PROJECT TITLE: *Jefferson Commons Lot 22A* ZONE ATLAS / DRNG. FILE #: *F-17-D61V*

JEFFERSON COMMONS

RE: DRAINAGE & GRADING PLAN FOR JEFFERSON COMMONS LOTS 22, 23, 24, 27, 28 & 29 (F-17/D61V); RECEIVED JANUARY 4, 1995 FOR BUILDING PERMIT APPROVAL; ENGINEER'S STAMP DATED 1-3-94

RE: RESPONSE TO COMMENTS DATED 1-17-95 FOR JEFFERSON COMMONS LOTS 22, 23, 24, 27, 28 AND 29 (F-17/D61V)

GRADING/DRAINAGE PLAN

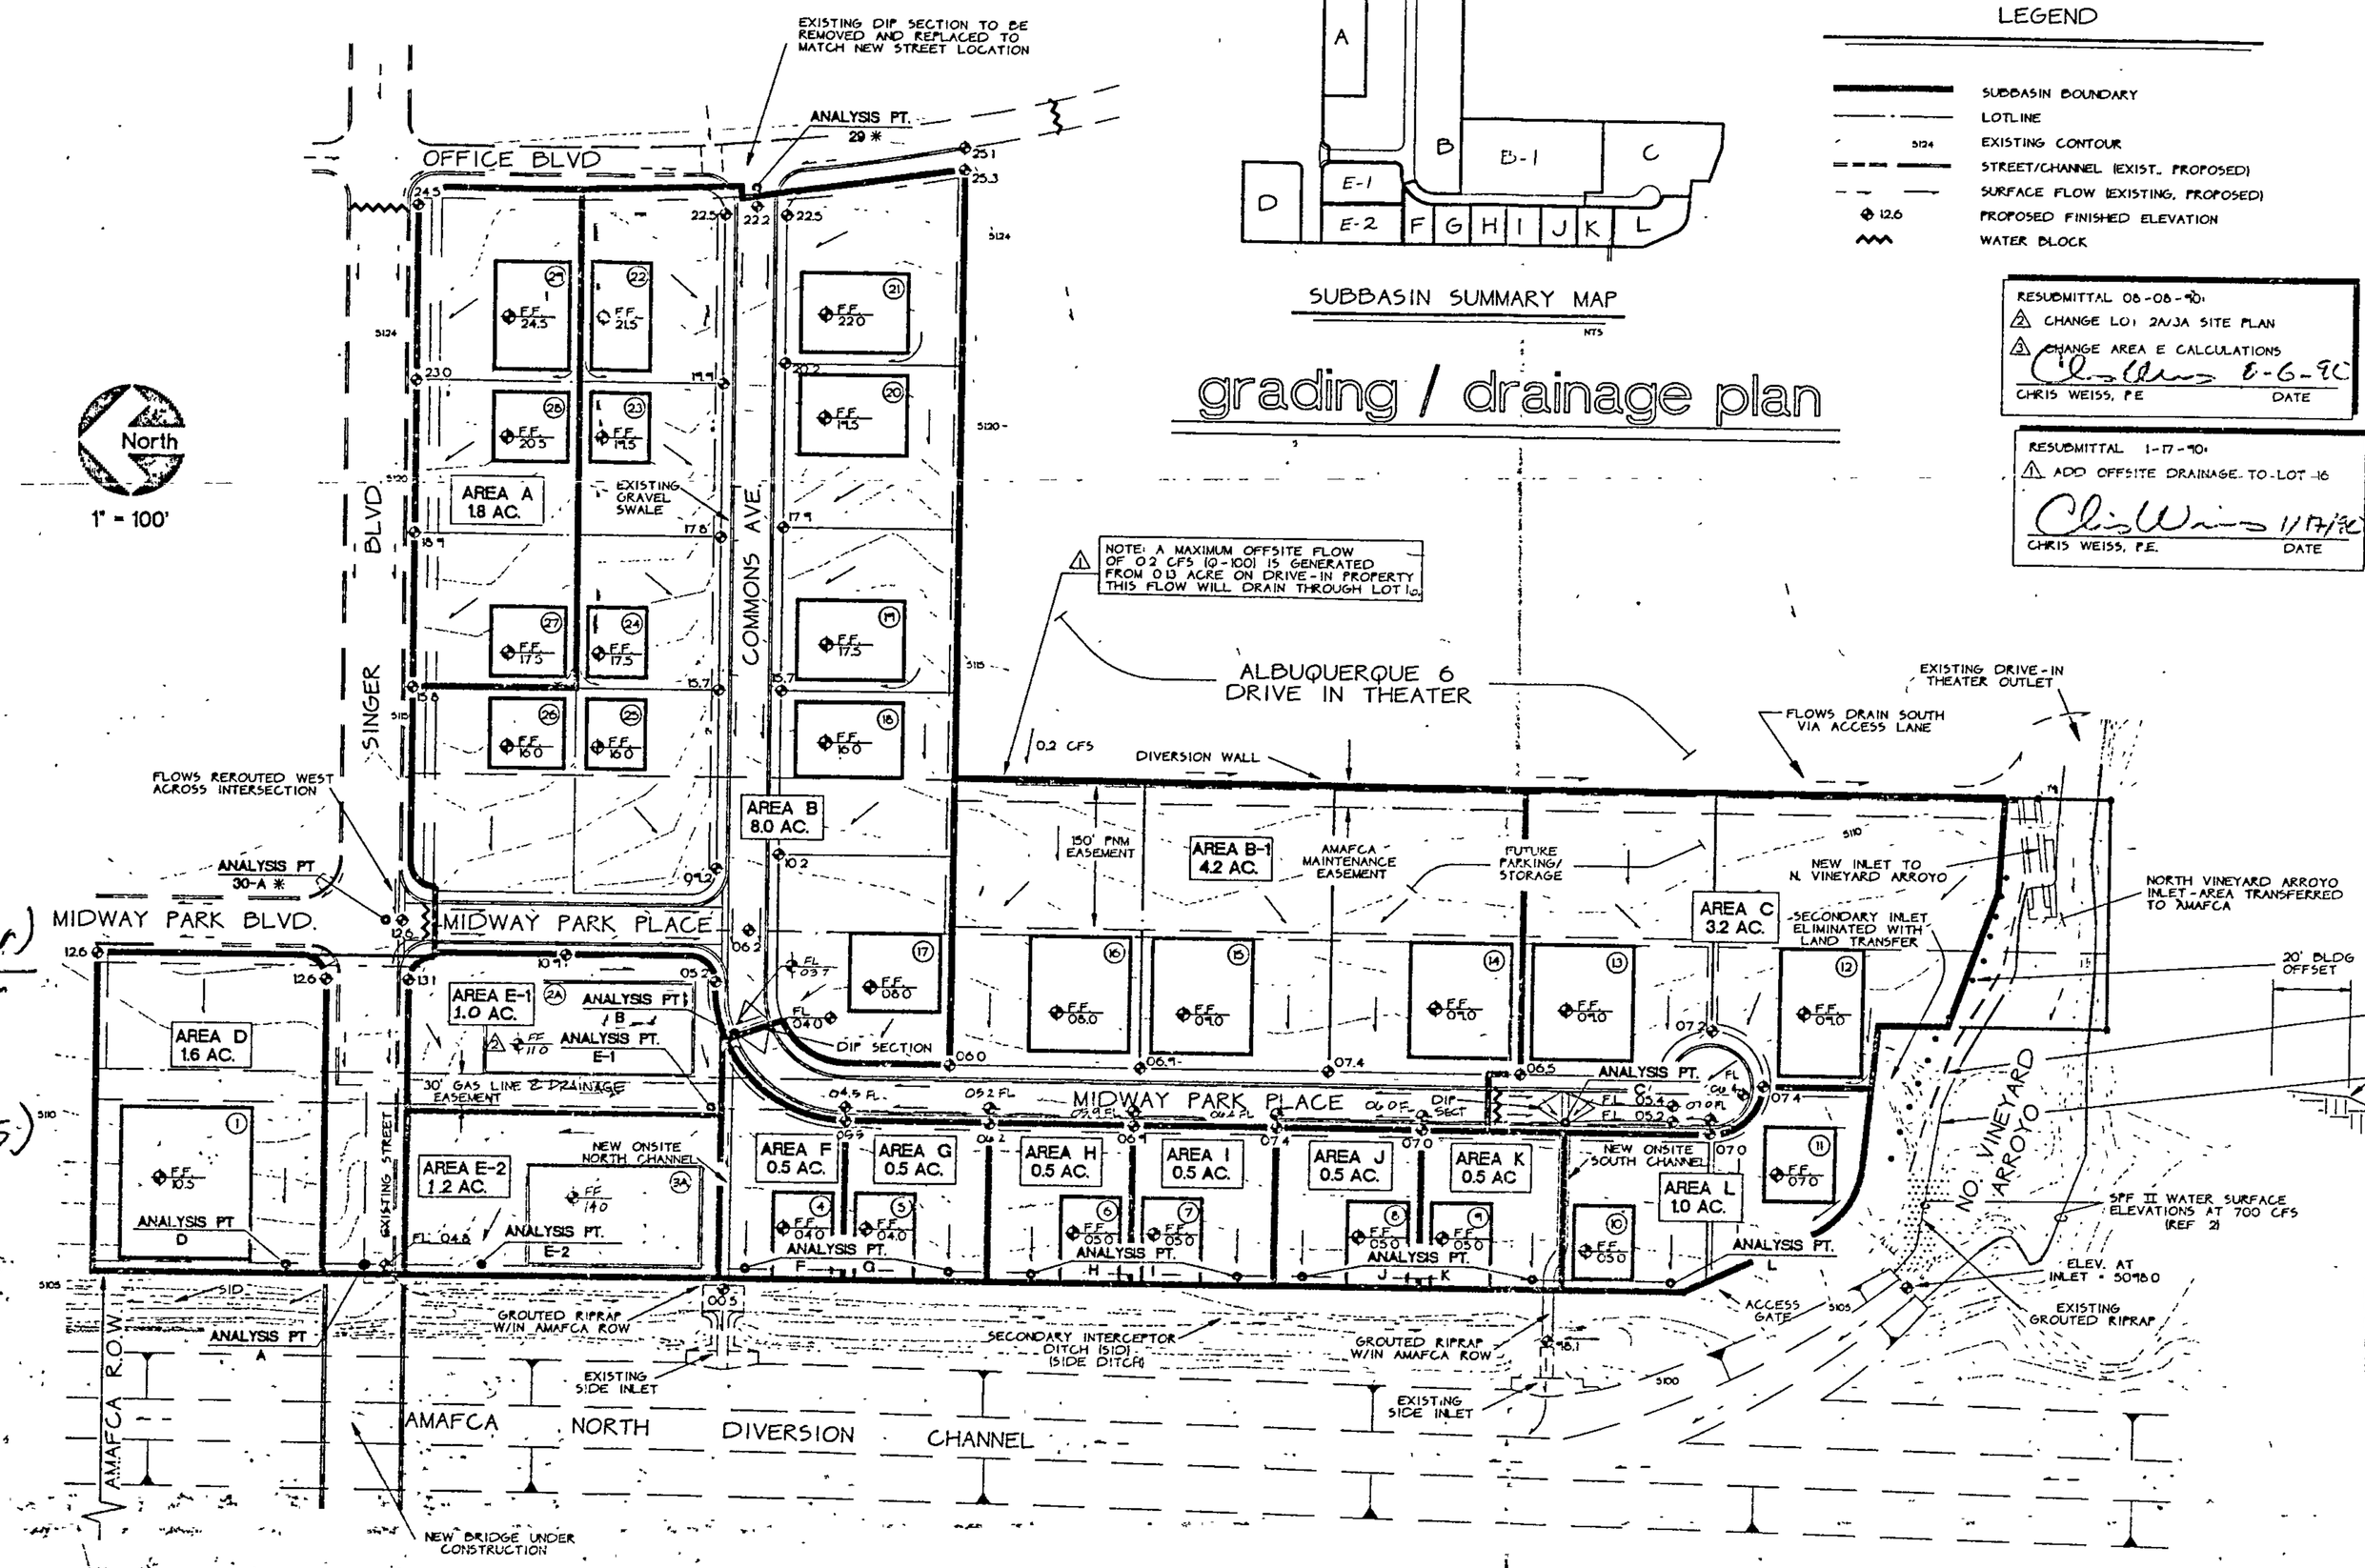
2. The proposed Drainage Plan does not conform to the approved Master Grading /Drainage Plan for Jefferson commons revised 8-6-90. The Master Plan indicates that 50% of the site drains to Singer & 50% to Commons instead of 34% to Singer & 66% to Commons as proposed. If the proposed plan does not conform to the approved Master Plan then downstream capacity must be verified independently.

2. Per the Master Grading / Drainage for Jefferson Commons revised 8-6-90, the downstream capacity of the North Channel was designed to accept 67 cfs based on fully developed on-site / off-site basins with a time of concentration (Tc) of 28 minutes at the point of study. The on-site flows released into Commons Avenue all have a Tc of 10 minutes or less and will pass through the North Channel prior to the off-site flows reaching the entry point of the North Channel.

20'
MMONS PLACE
14'
LOADING
MAX. BLDG. HGT. = 1 STORY = 24'
MAX. BLDG. HGT. = 2 STORY = 30'
NOTE: Buildings shown reflect intent. Total buildings shall not exceed number shown, e.g.: lots 2 and 3 may be [redacted] buildings; lots 22 thru 29 may become one building.
Reference Sheet #1
MAR - 9

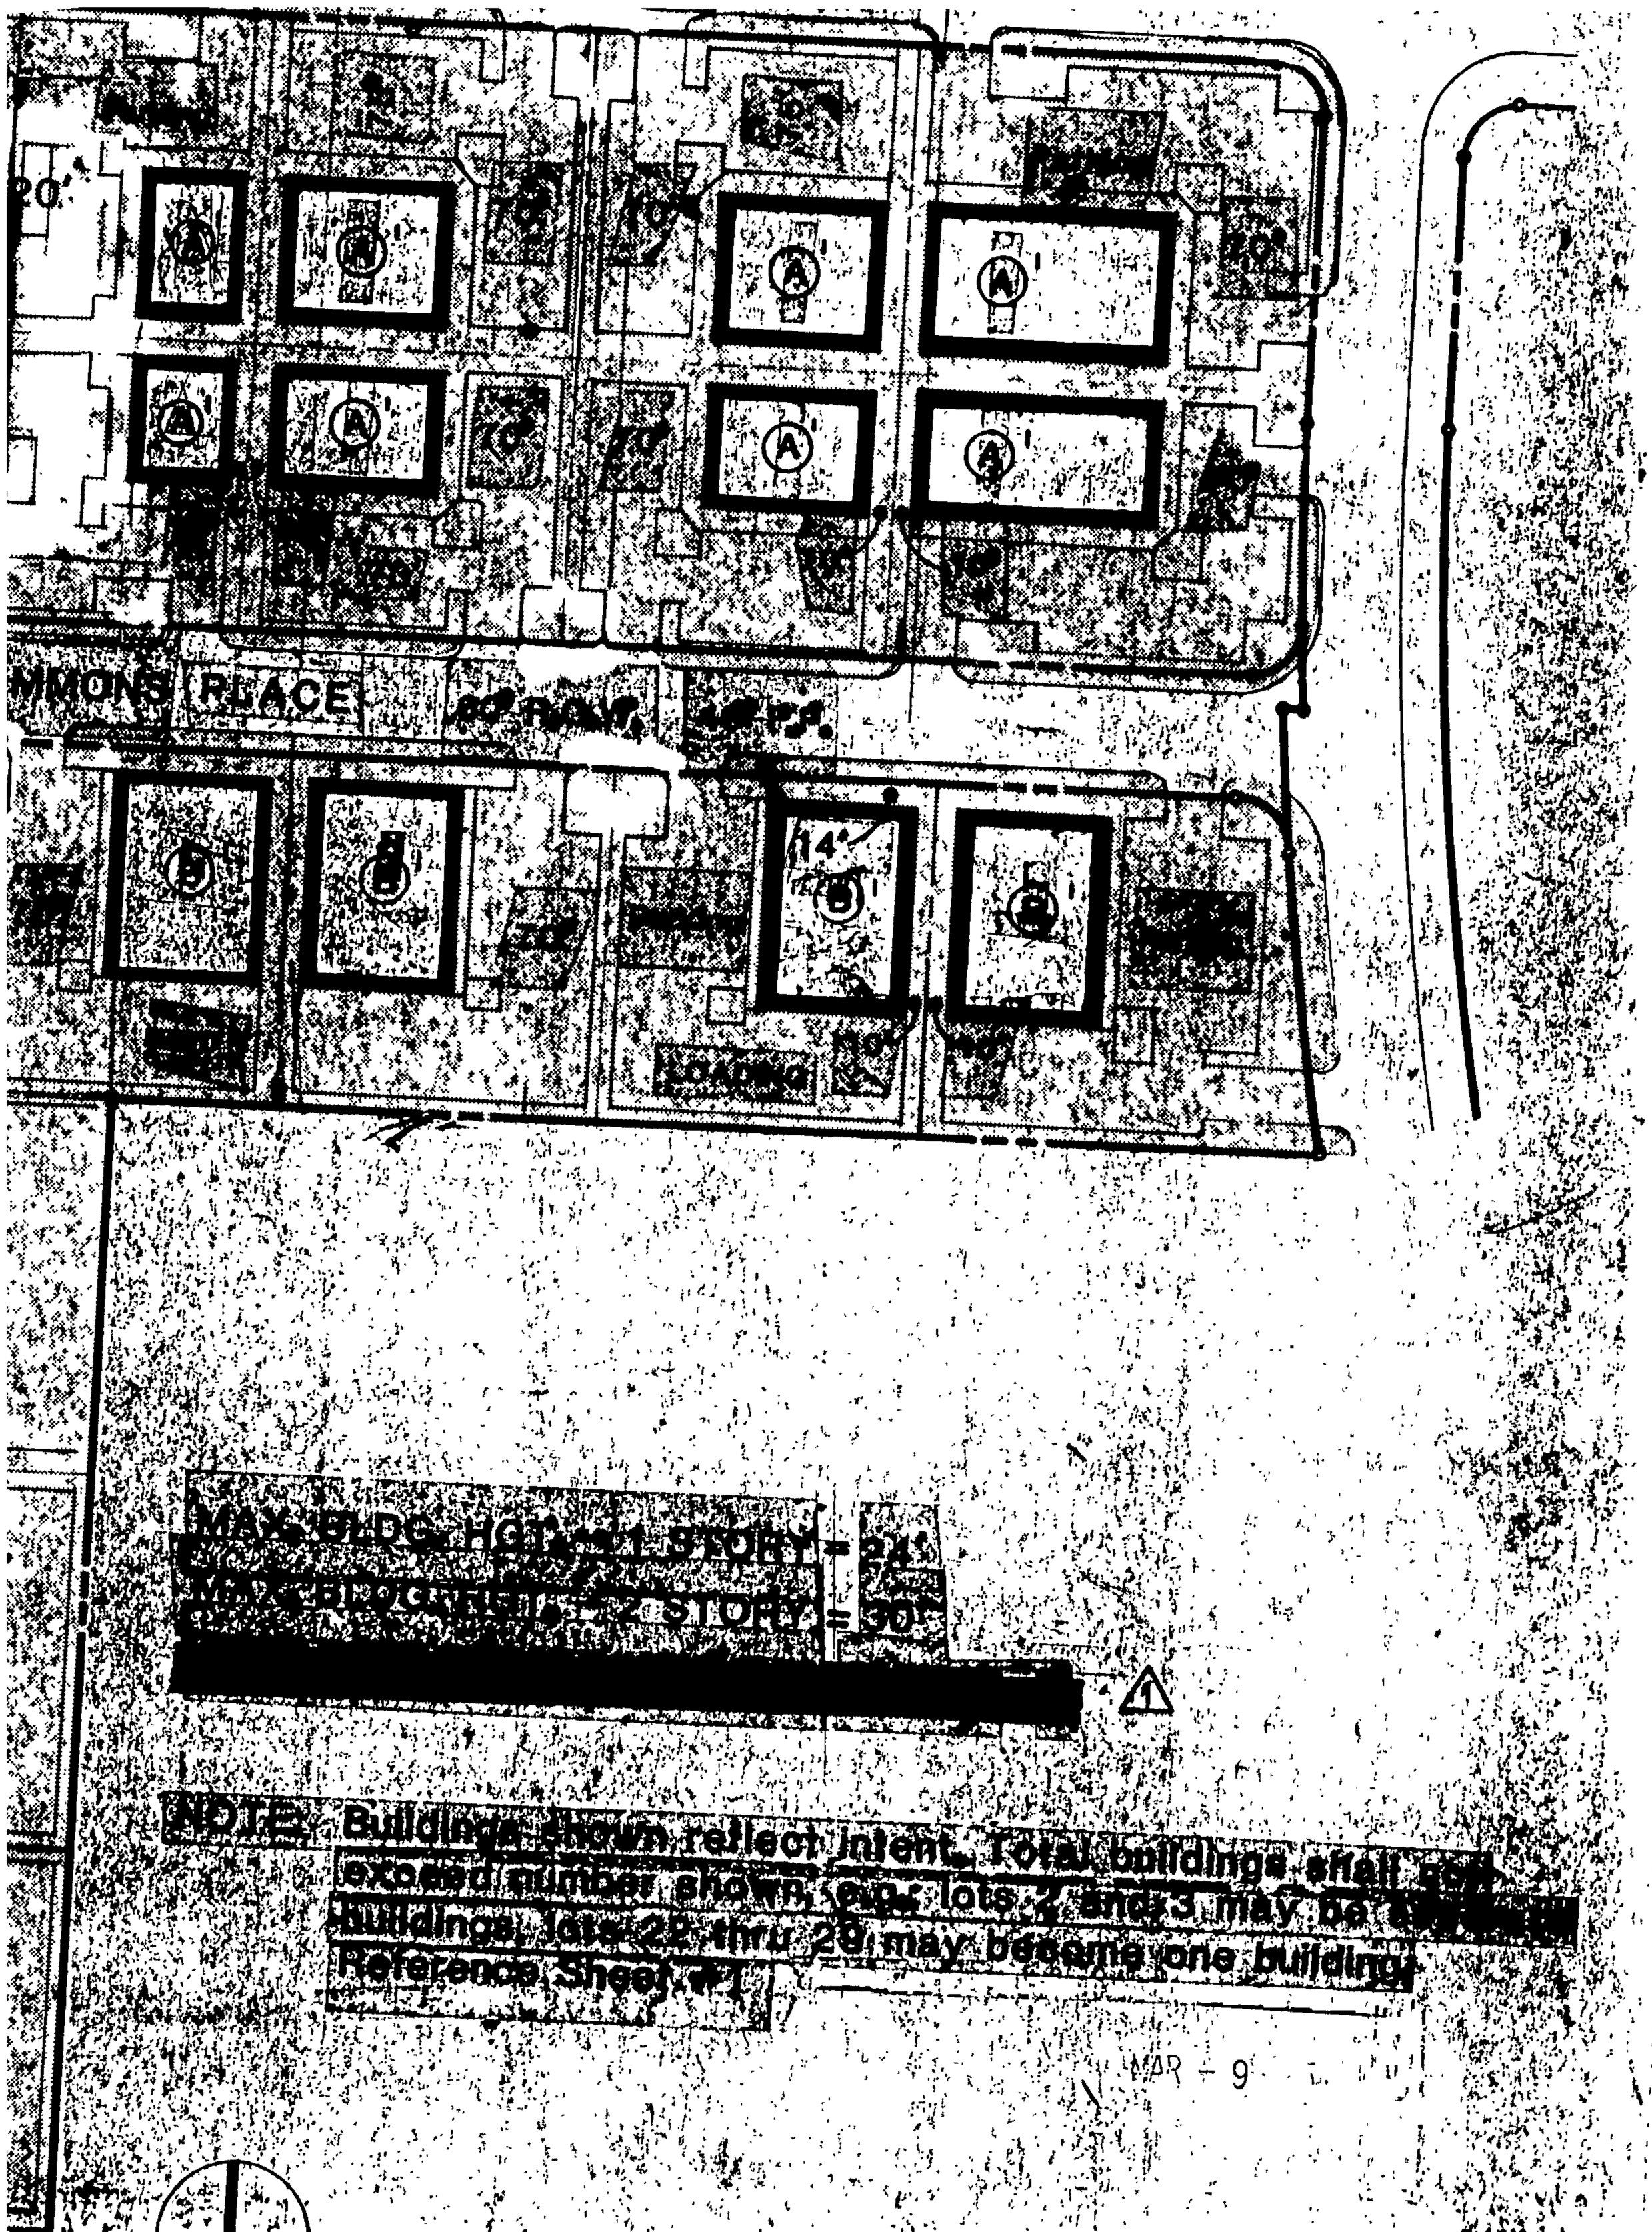
1. All land zoned IP must have an approved Site Development Plan for Building Permit. Is there an approved Site Development Plan for this project? If so, what is the DRB number?

1. This property is zoned SU-1 for IP or C3 uses. The Site Development Plan for the property (Z-88-51) clearly states that "*Total buildings shall not exceed number shown, e.g.: ...lots 22 through 29 may become one building...*". I have enclosed a Xerox copy of this area from the set.
